Viking CCS Pipeline

9.40 Design Changes 3 and 4: Environmental Technical Note

Document Reference: EN070008/EXAM/9.40

FIGURE TITLE
Figure 4
Design Change 3 - Relocation of Temporary Laydown and Access Area

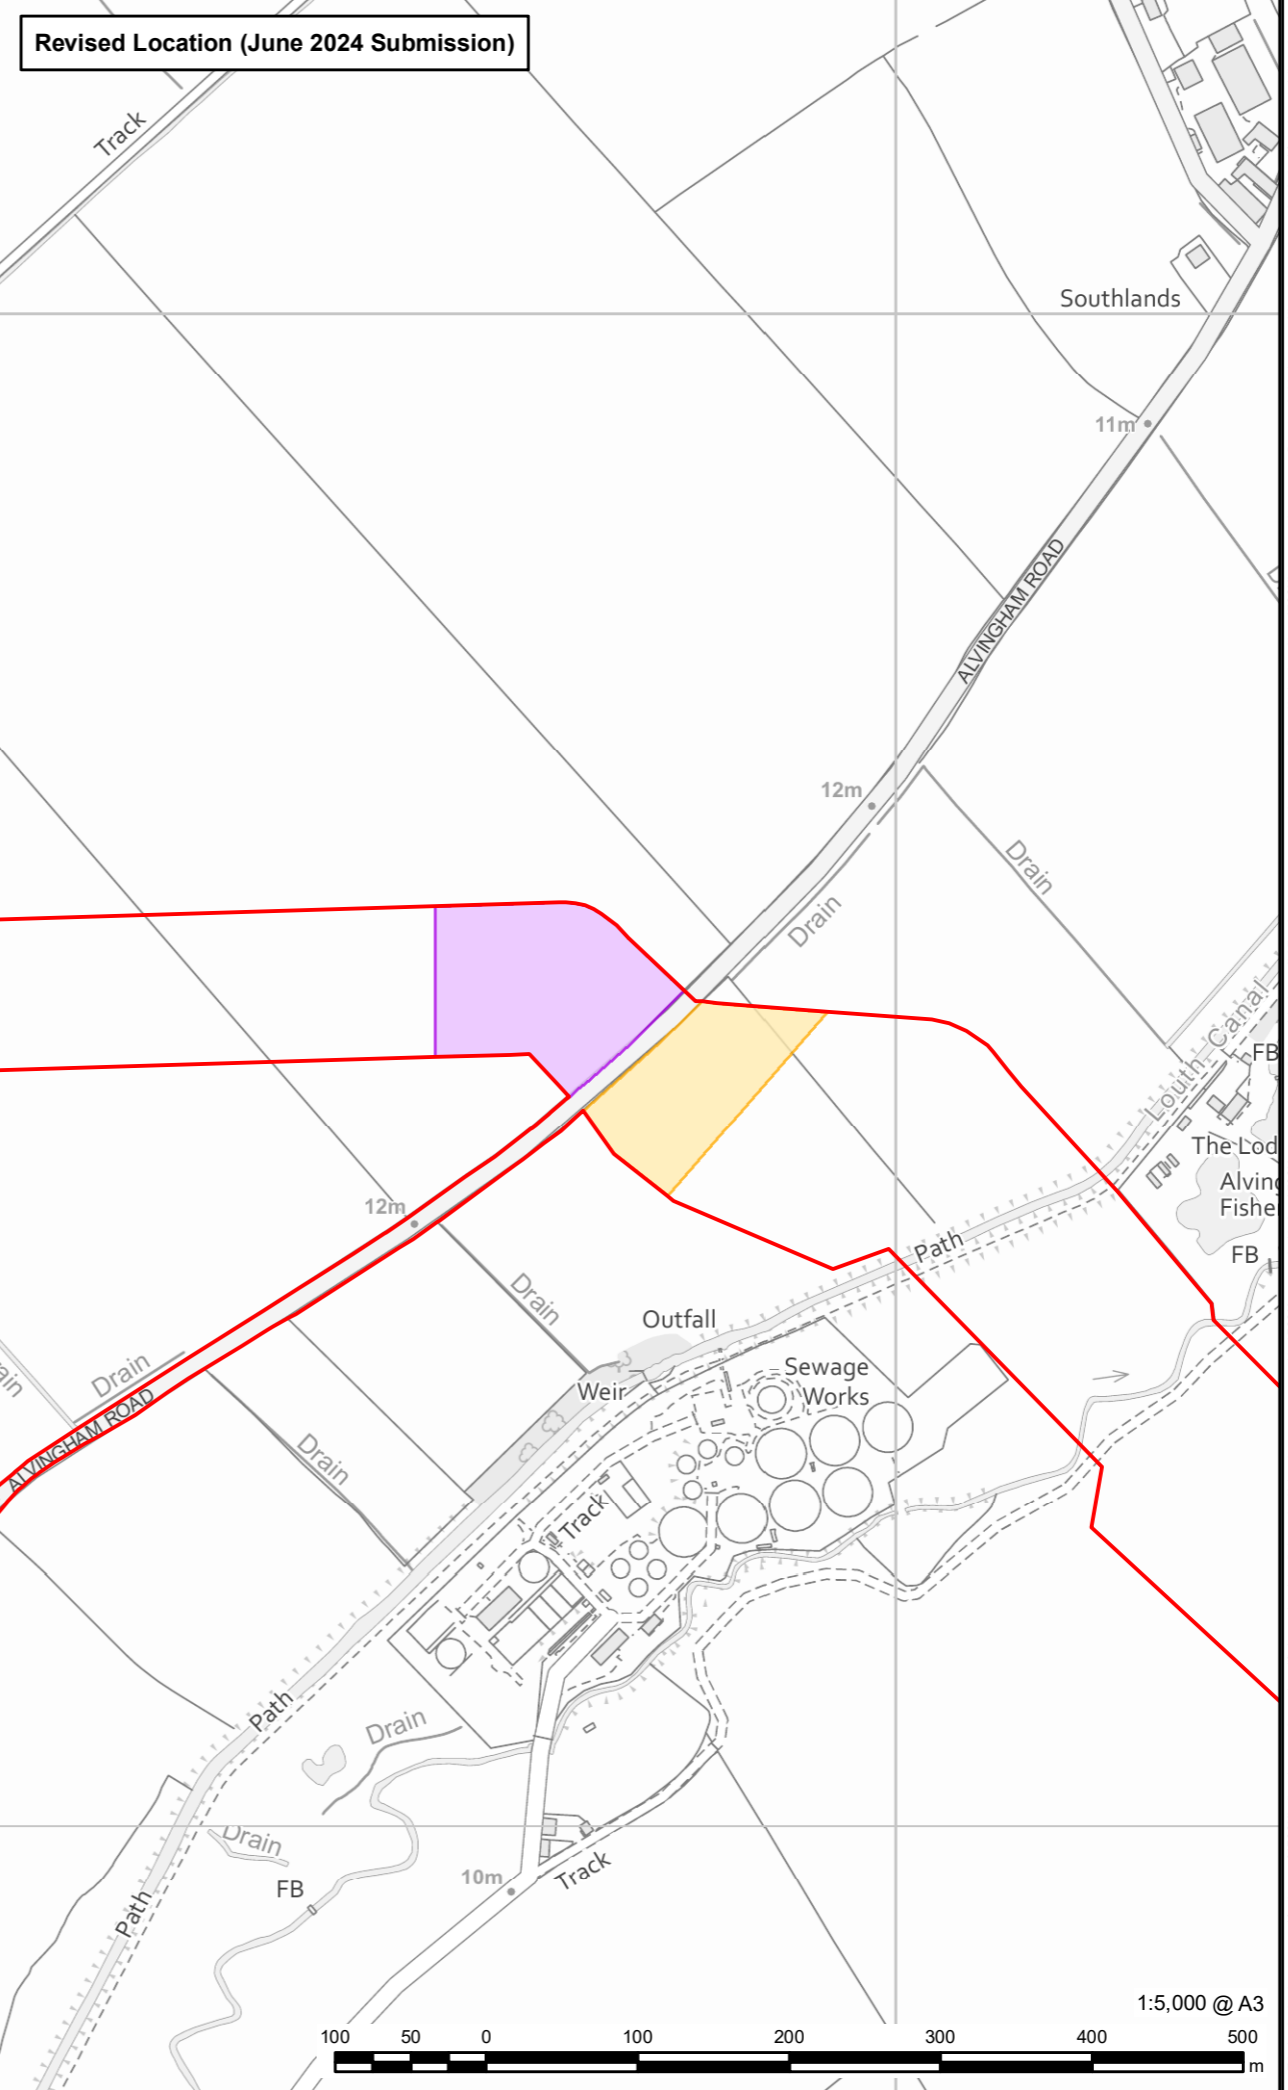
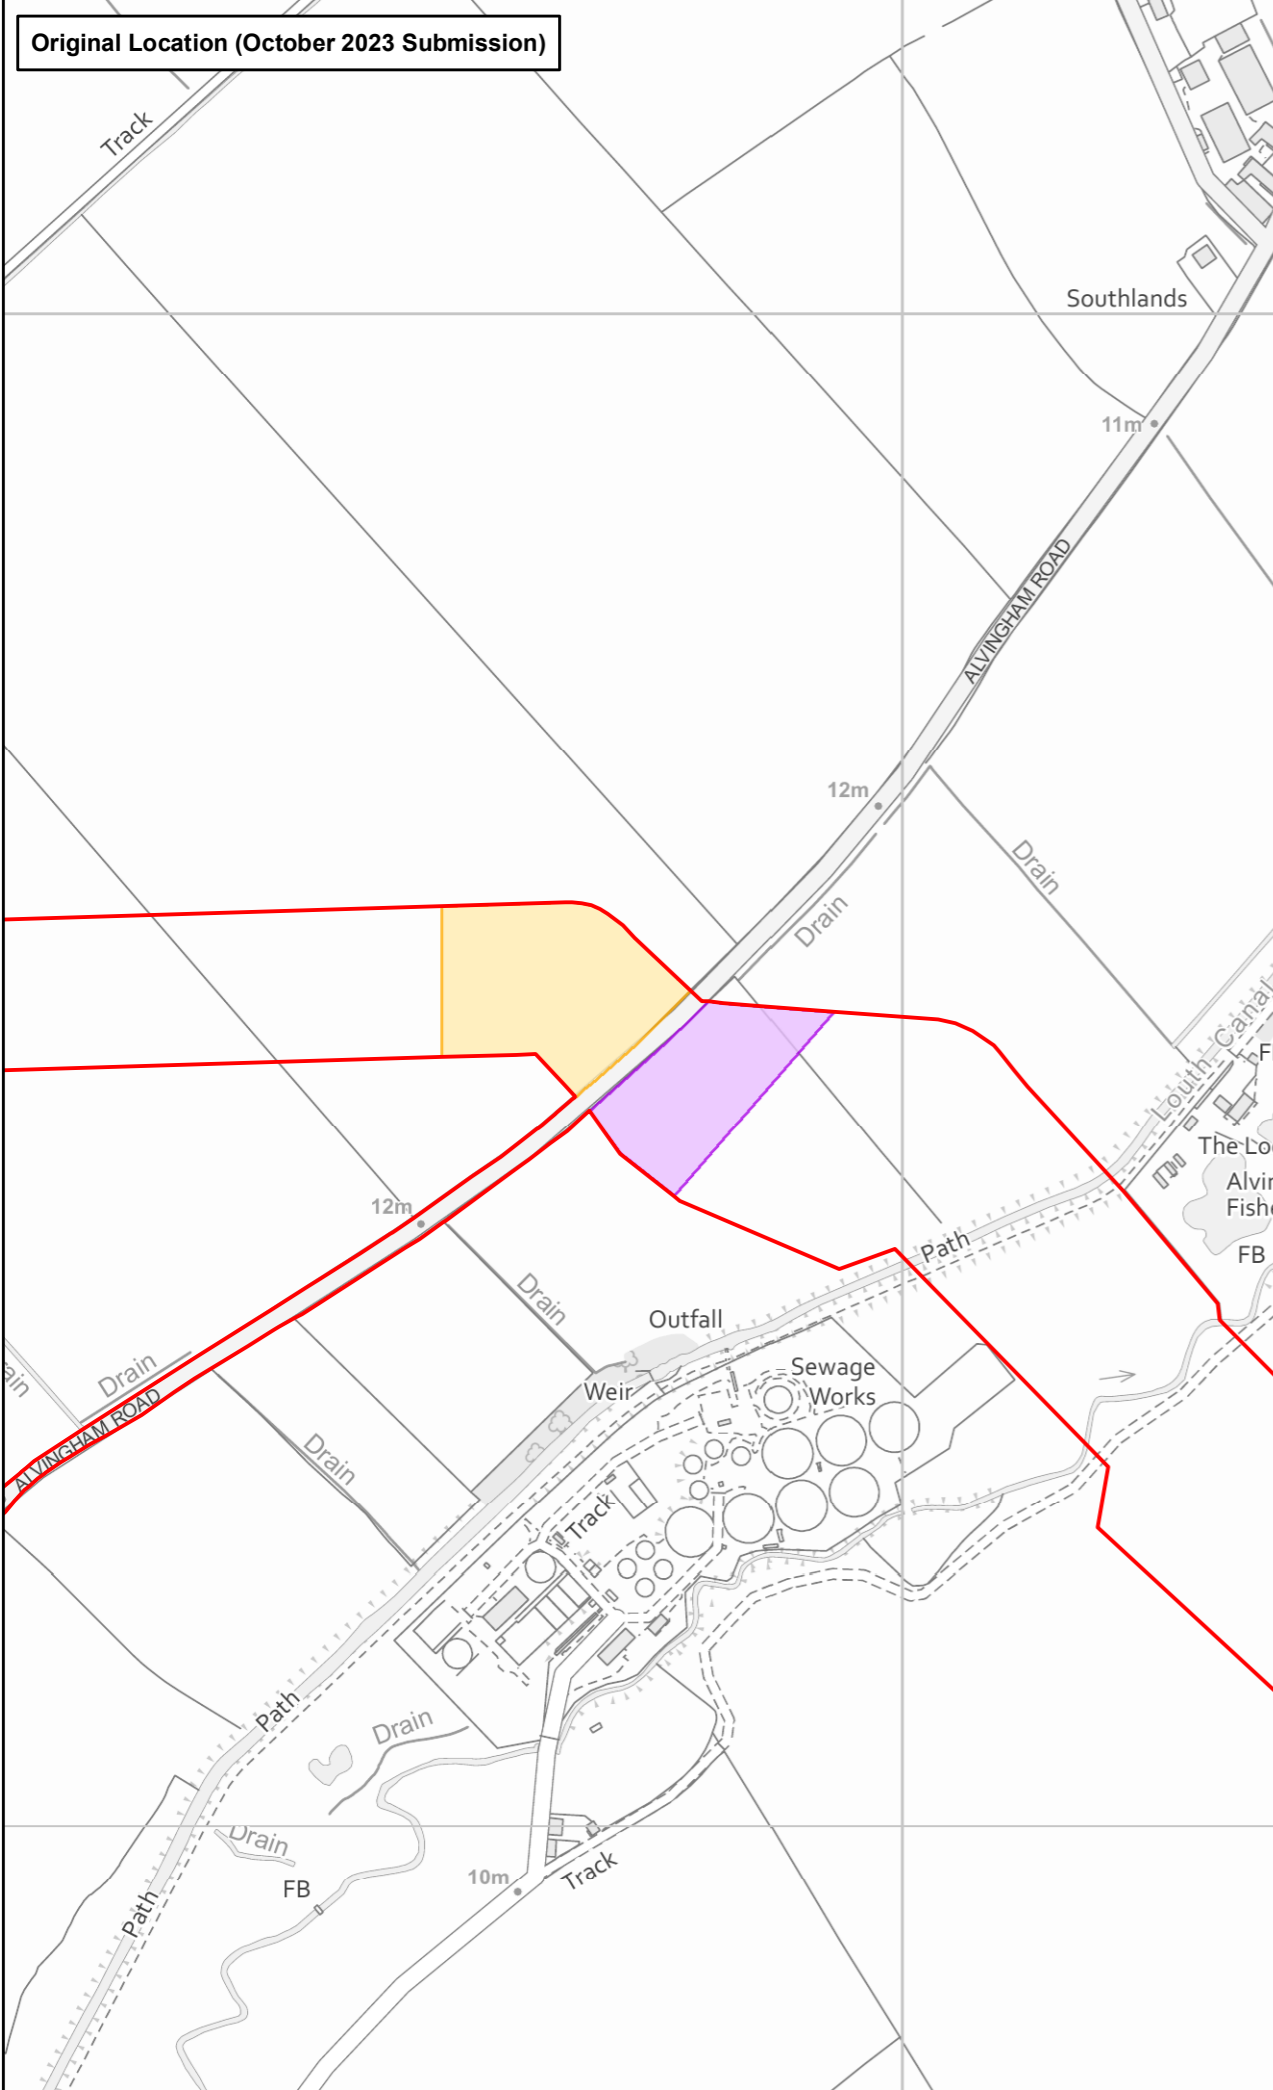
2.2.3 **Figure 1** provides a close-up overview of the change in location of Block Valve Station 3, whilst **Figure 2** provides an updated version of Figure 3-10 as originally presented within ES Volume II Chapter 3: Description of the Proposed Development [APP-045]. **Figure 3** shows the indicative layout of Block Valve Station 3, with only the orientation changed. **Figure 4** shows the new location of the temporary access and laydown area, compared to the original location.

Figure 5
Design Change 4 - Re-alignment of Order Limits at Anglian Water WTC

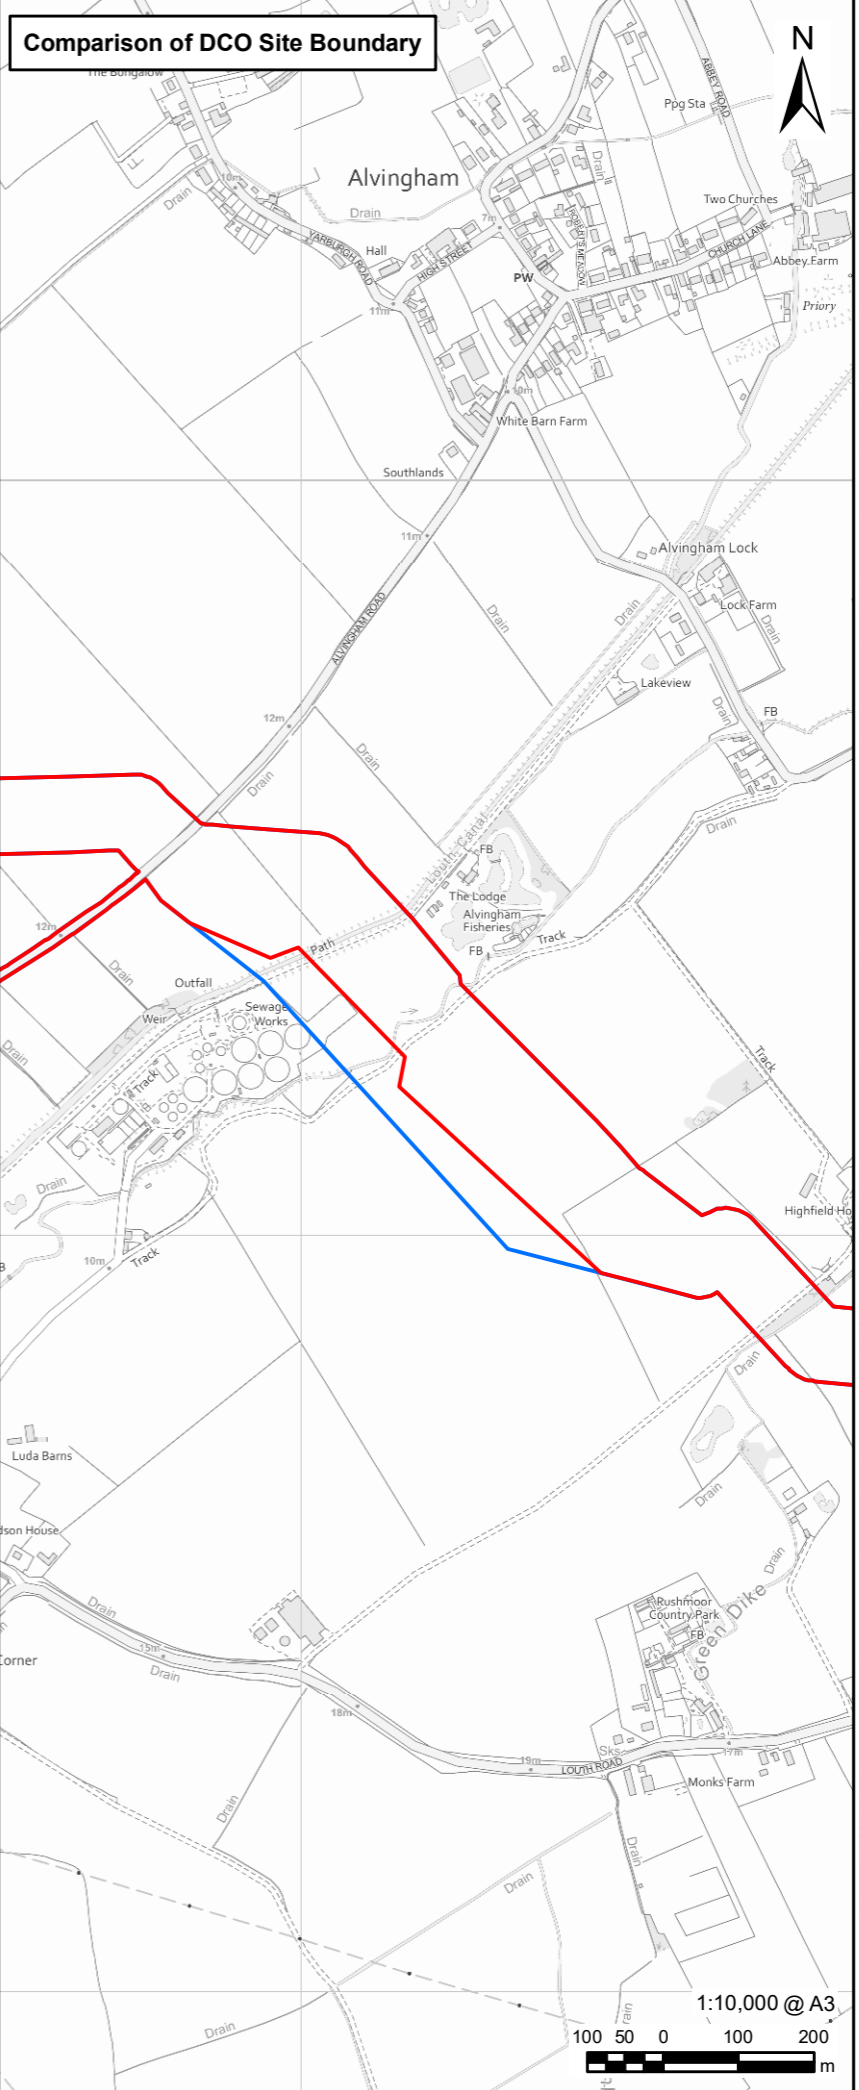
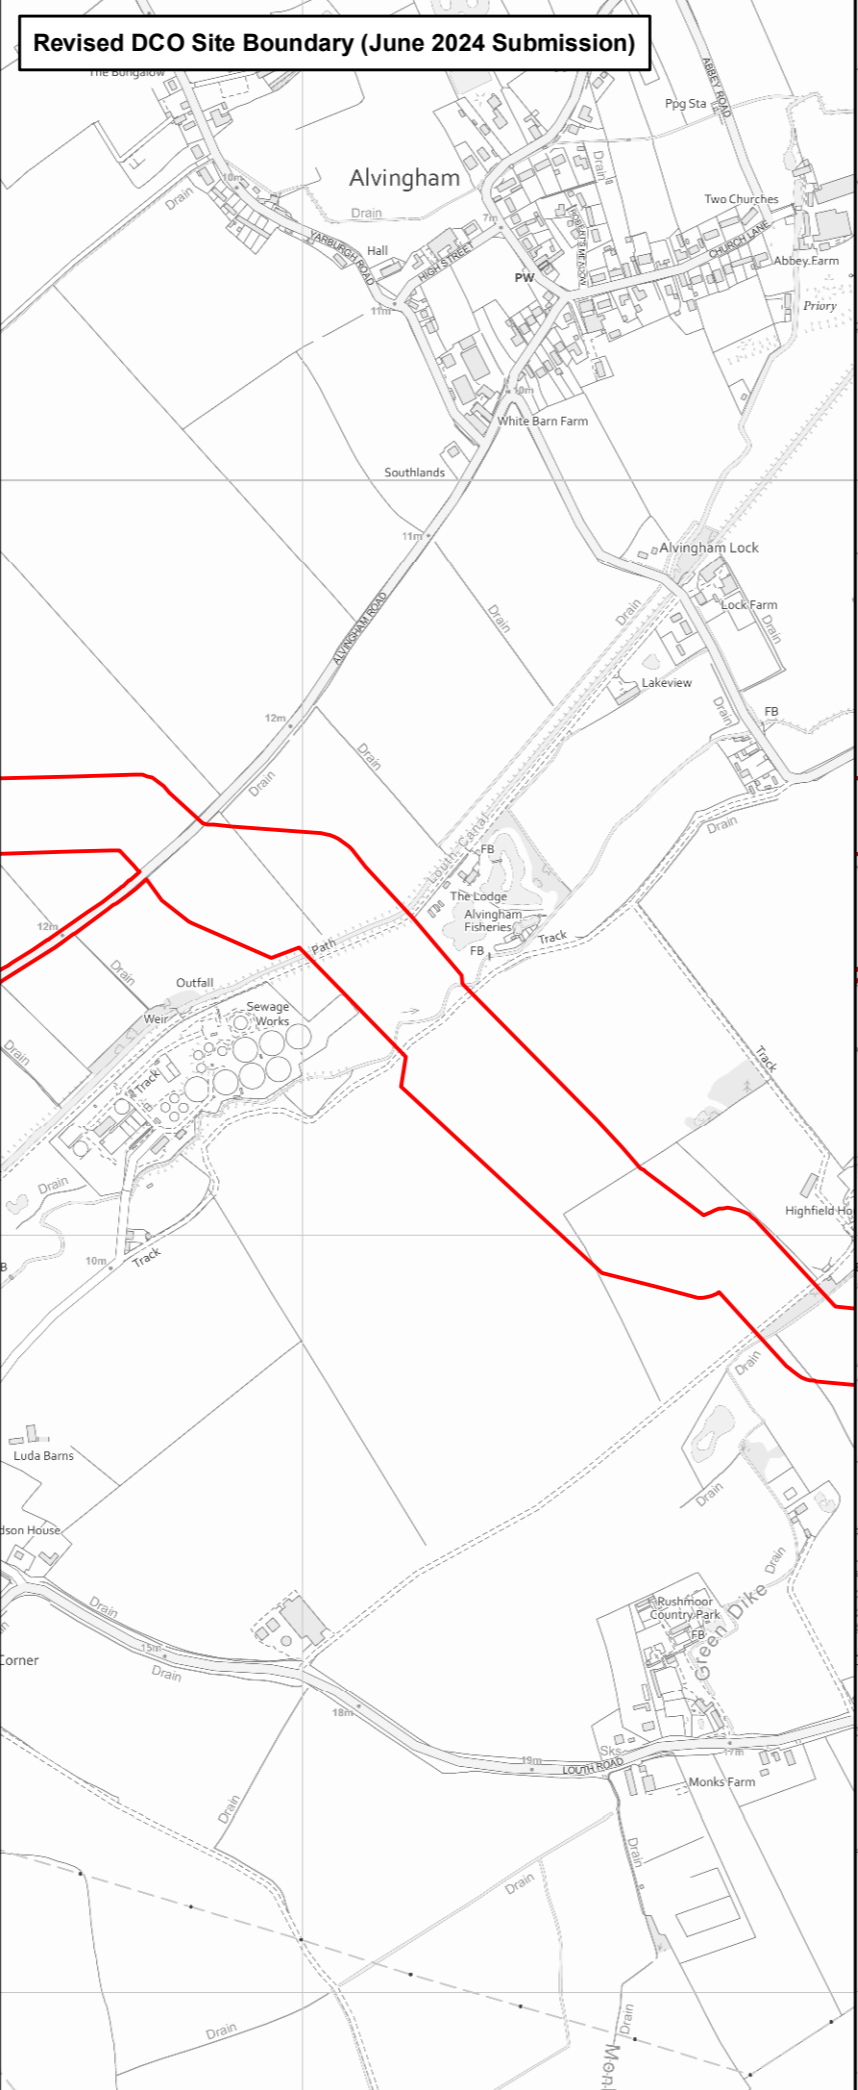
- 2.3.1 Following on from further consultation and discussions with Anglian Water, the Applicant has agreed to reduce the width of the Order Limits over a parcel of land that they own that is east of the LWRC. This has resulted in the order limits being reduced from 200 m wide to 135 m wide. No other changes are anticipated at this location and the LWRC will still be crossed using a trenchless technique (currently assumed as Horizontal Directional Drilling).
- 2.3.2 The Order limits to the south east of the field owned by Anglian Water have also been reduced in width, from 200 m wide to 150 m wide, as a consequence of the above change. **Figure 5** shows the change to the Order Limits for Design Change 4.

3.3.1 The proposed change to the Order Limits as a result of Design Change 4 has been reviewed. This change results in a reduction of the Order Limits by 3.3 hectares, narrowing the order limits over the field to the east of the Anglian Water LWRC, from 200 m at its widest point down to 135 m. The proposed trenchless crossing under Louth Canal, River Lud, and land owned by Anglian Water is still expected to be via horizontal directional drilling.

Additionally, the Order Limits have also been reduced to the south of the Anglian Water LWRC, down from 200 m to 150 m at its widest point.

Figure 36 Viewpoint Photomontages - Viking CCS Pipeline
 Viewpoint 22: Cherry Tree Lane/PRoW, Alvingham

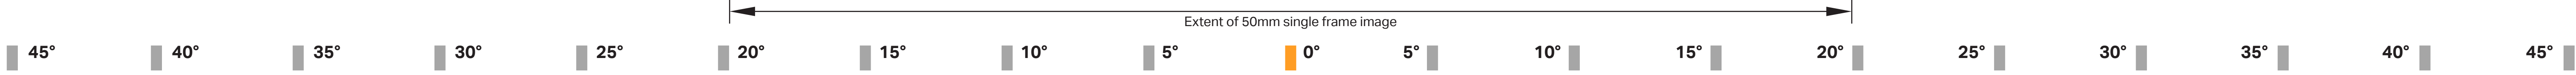
5.1.2 The Louth Road Block Valve Station (BVS) has been relocated to the southern field off Louth Road. We have undertaken updated visualisations to reflect the change in location. It is judged that the assessment within the ES Chapter 7 [APP-6.2.7] on recreational/ PRow receptors would not differ as a result of the alternative location. Although the BVS is closer to the viewpoint, it is not more prominent than was the case for the previous location.

- 1. It is set lower in the landscape (originally at circa 14m AOD now at circa 11m AOD);
- 2. Intervening vegetation provides a higher degree of screening; and
- 3. Vegetation to the rear provides a backdrop, reducing skyline effects.
